**BOARD ACTION REPORT – APPEALABLE ITEM**

**Project Name:** 502 East Atlantic Avenue  
**Project Location:** 502 East Atlantic Avenue  
**Request:** Amendment to the Blanket Sign Program  
**PCN:** 12-43-46-16-G6-000-0010  
**Board:** Site Plan Review and Appearance Board  
**Meeting Date:** May 25, 2022  
**Board Action:** 7 – 0  
**Brief Description:** Amendment to the Blanket Sign Program

## SITE PLAN REVIEW AND APPEARANCE BOARD STAFF REPORT

Meeting	File No.	Application Type
May 25, 2022	2022-119-SPF-SPR-CL1	Amendment to the Master Sign Program
Property Owner	Applicant	Agent
MROD Realty CORP	MORD Realty CORP	Mark Gregory

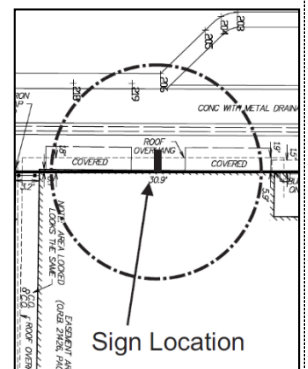
The proposed projecting sign on the west elevation (graphic at right) meets the intent of the code pursuant to LDR Section 4.6.7(E), which allows a projecting sign up to 30 SF. However, pursuant to LDR Section 4.6.7(3)(c)(8), *when a sign requires a permit and is located within an easement or right-of-way, an agreement in a form acceptable to the City Attorney shall be executed between the property owner and the City. The agreement shall be executed by the City Manager, or their designee. A performance bond or acceptable substitute guarantee may be required.* If the projecting sign is approved, a Hold Harmless agreement will need to be executed prior to permit issuance.

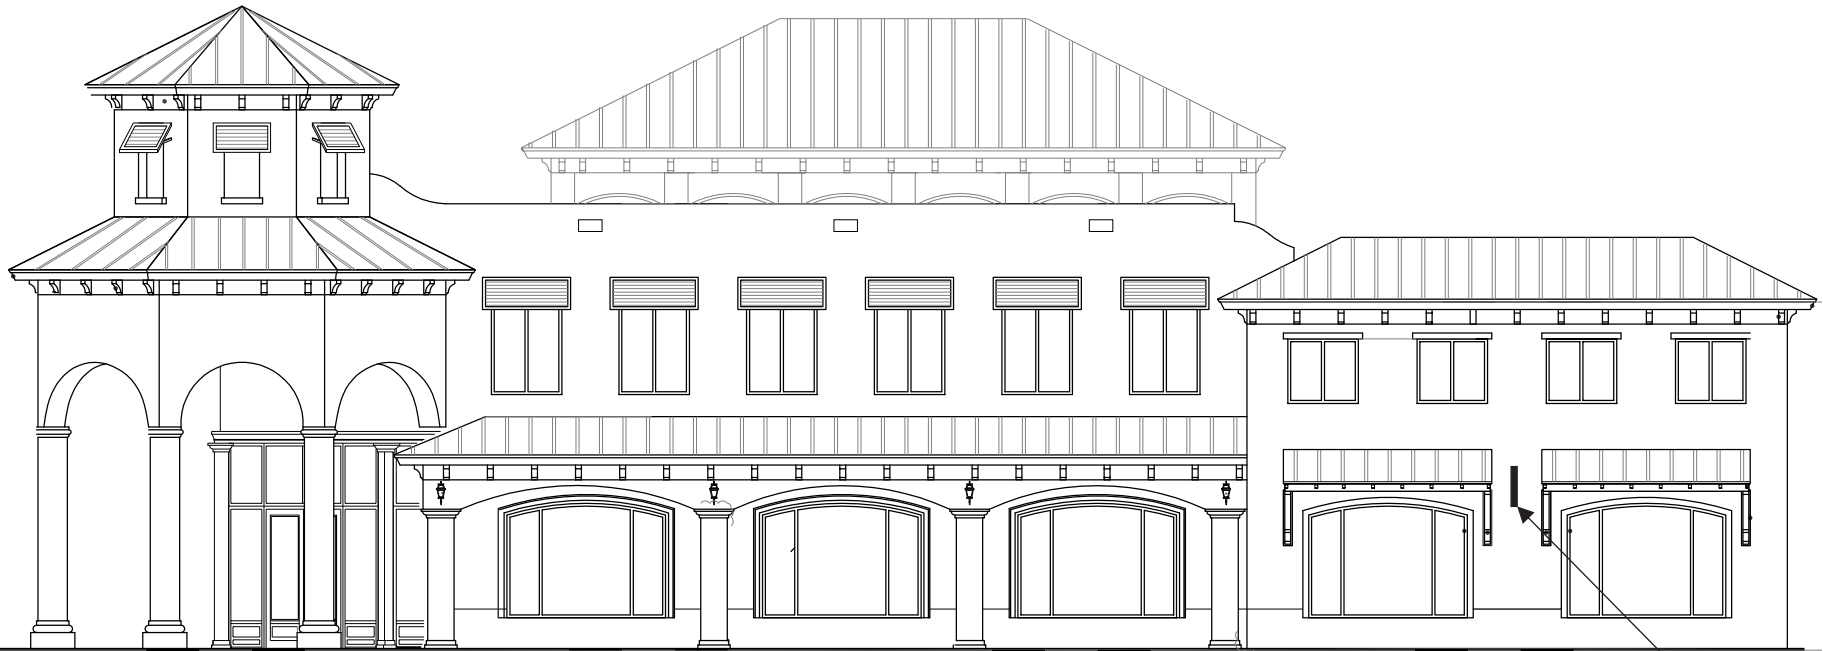
West Elevation (Costa Organic Kitchen) Approved administratively as it met the perimeters of the Blanket Sign Program and a new projecting sign 3 feet by 1 foot 5 inches for a total of 4 feet 5 inches.
